ADDENDUM
NUMBER TWO

Renovations and Addition

Keystone Regional Youth Center

Invitation to Bid No. 26-16 GR
USA Project No. R2024.0111.01

PLAN VIEW

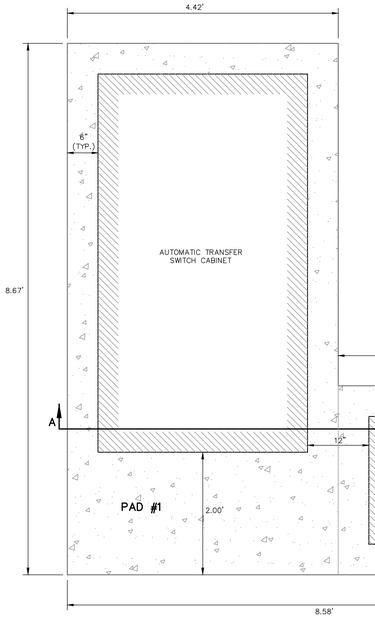
ADDENDUM #2 REVISION:
REVISE TO ELIMINATE CHAMFER

10 ROOF LADDER DETAIL
SCALE: 3/4" = 1'-0"

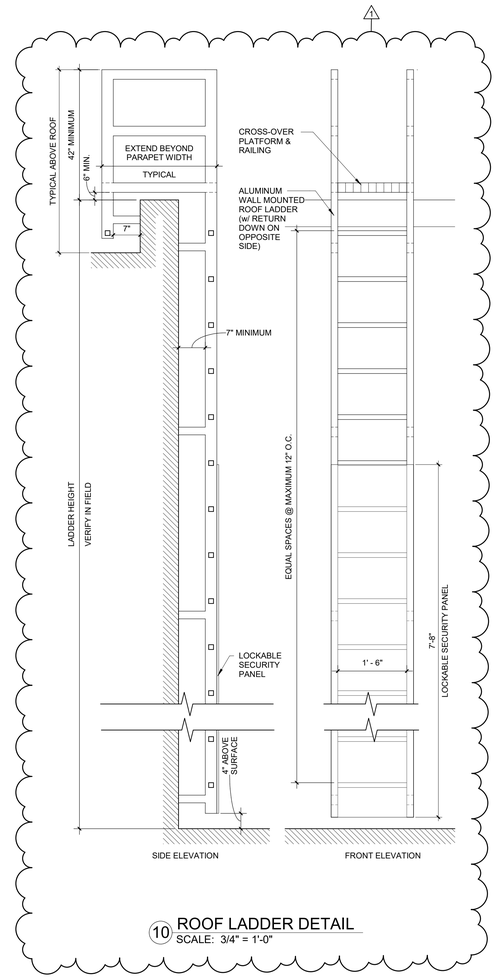
Item 22: DELETE Drawing A-146 in its entirety and REPLACE with the attached Drawing A-146. Added roof ladder detail. Revised roof detail notes.

A WALL SECTION
SCALE: 3/4" = 1'-0"

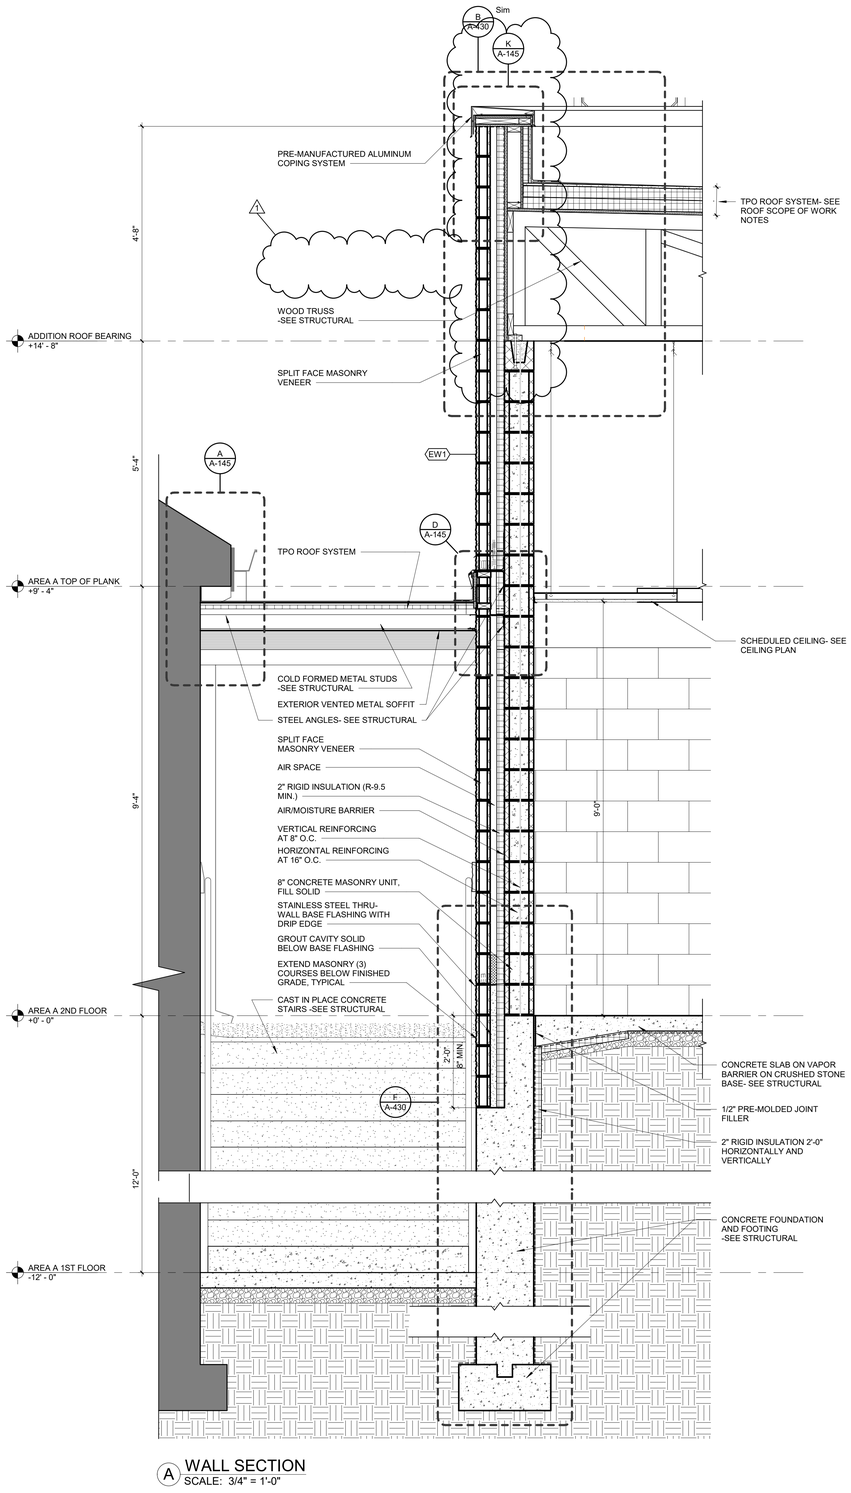
Item 29: **DELETE** Drawing A-430 in its entirety and **REPLACE** with the attached Drawing A-430. Revised wall section. Revised notes on sections.

Q39: The parapets are detailed differently in the Architectural and Structural Drawings. The Architecturals show the following in Section A from sheet A-430 where the bearing appears to be a 2x4 plate on the 8" CMU bond beam. The parapet is fabricated with 4" CMU bearing on the 8" CMU.

A39: Follow the structural parapet details. Architectural details were revised to match structural. See attached drawings.

A A116 RESIDENTS KITCHEN ROOM ELEVATION
SCALE: 1/2" = 1'-0"

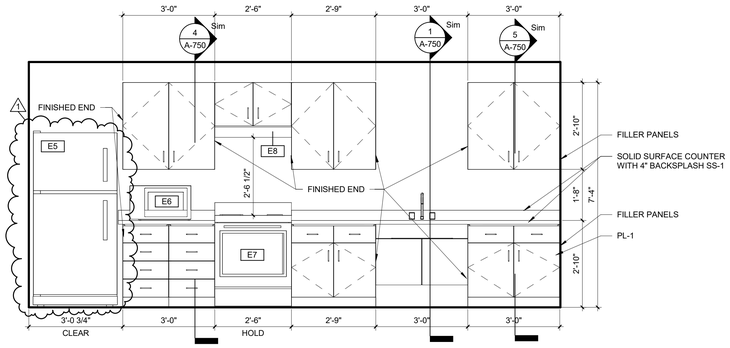
Item 31: **DELETE** Drawing A-730 in its entirety and **REPLACE** with the attached Drawing A-730. Added casework dimensions. Revised refrigerator model to match specification.

A35: Kitchen A116 receives E-8 Range Hood. See revised Addendum #2 Drawings.

1 PARTIAL FIRST FLOOR FURNITURE PLAN - AREA A
SCALE: 1/8" = 1'-0"

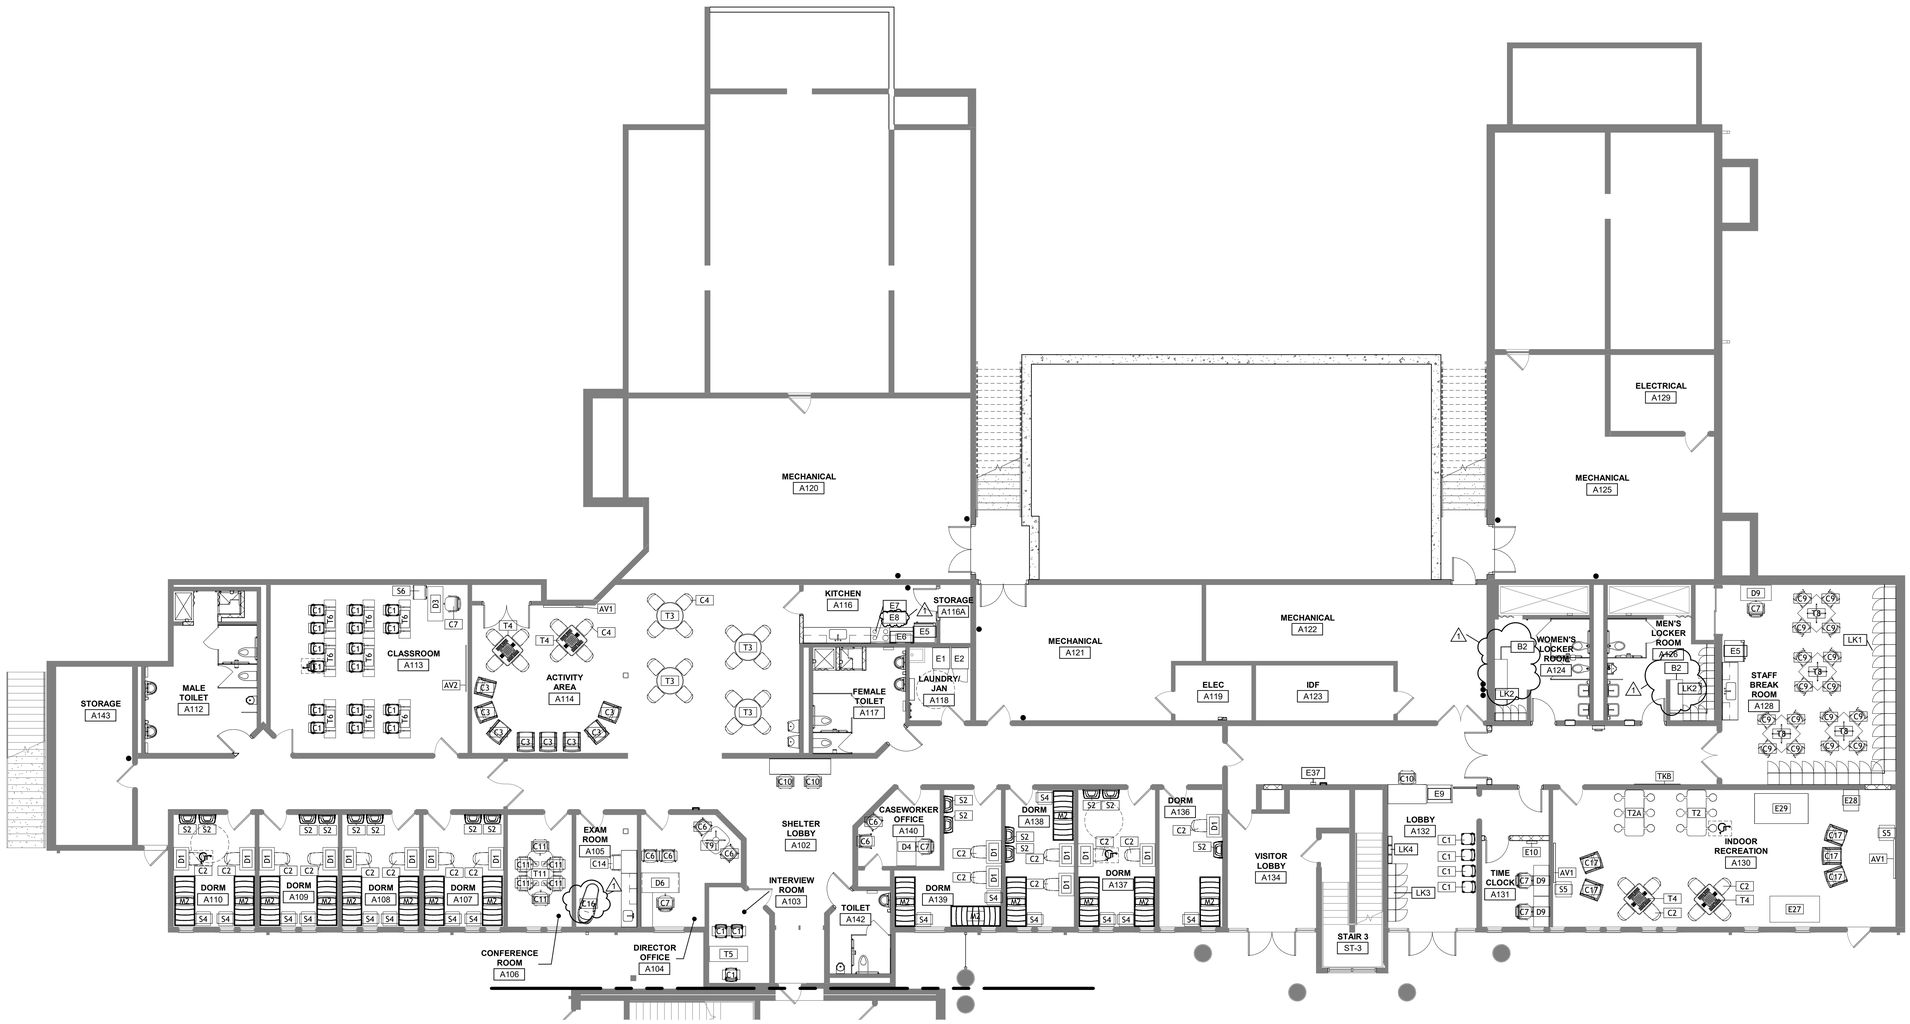
Q06: Drawing A-851, Room A105 shows a C15 furniture item but C15 is not listed on the furniture schedule. Please advise.

1 **LIGHTING PROPOSED - SECOND FLOOR - AREA B**

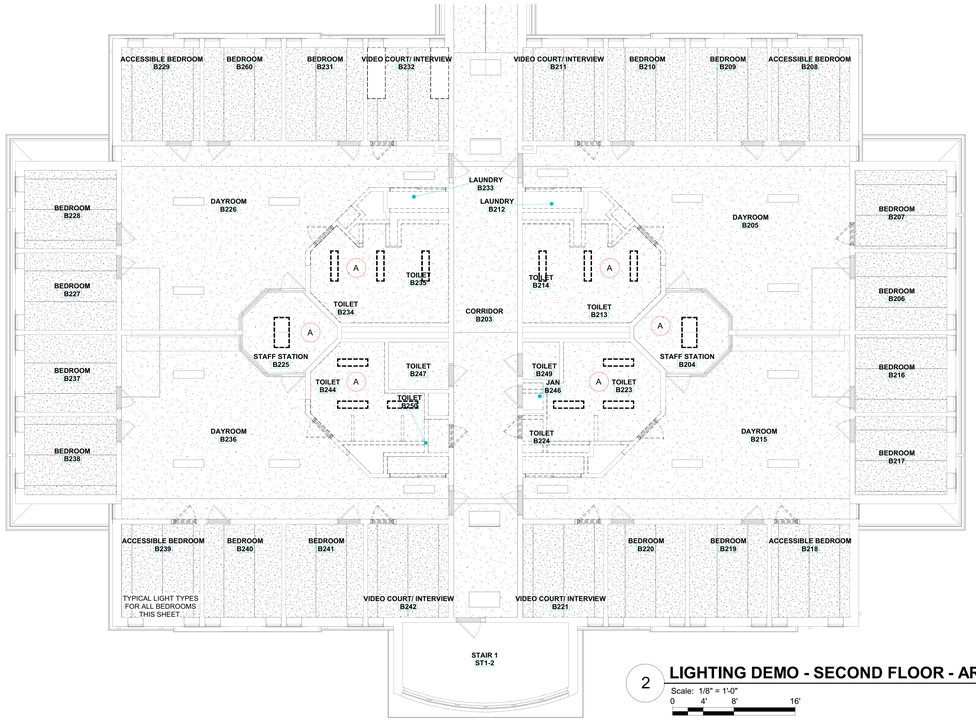
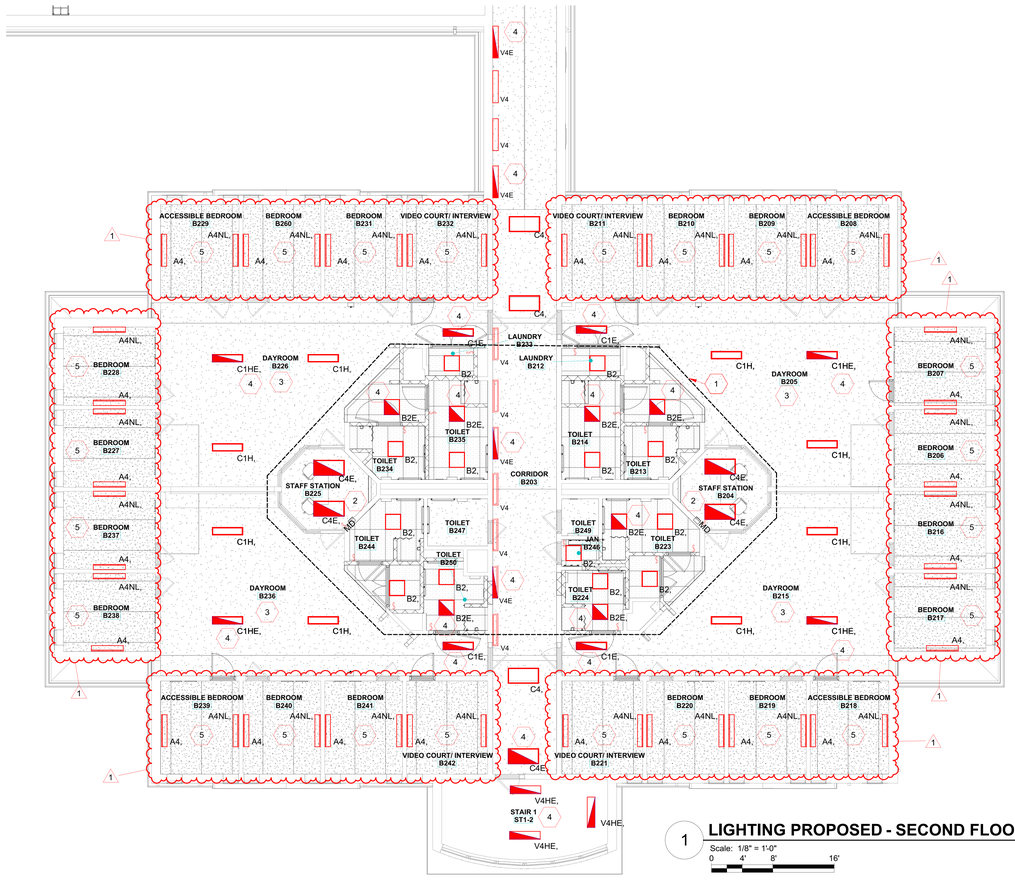
Q29: Drawing EL-104, RM B239 notes "Typical Light Types for all Bedrooms" and showing a Type A4 and A4NL in that room. Are we to assume each bedroom is to get new lighting? If so, provide lighting layout.

A29: Yes, Type 'A4' and 'A4NL' shall be provided in all bedrooms on EL-104. Attached drawing is clouded and tagged showing the layouts.
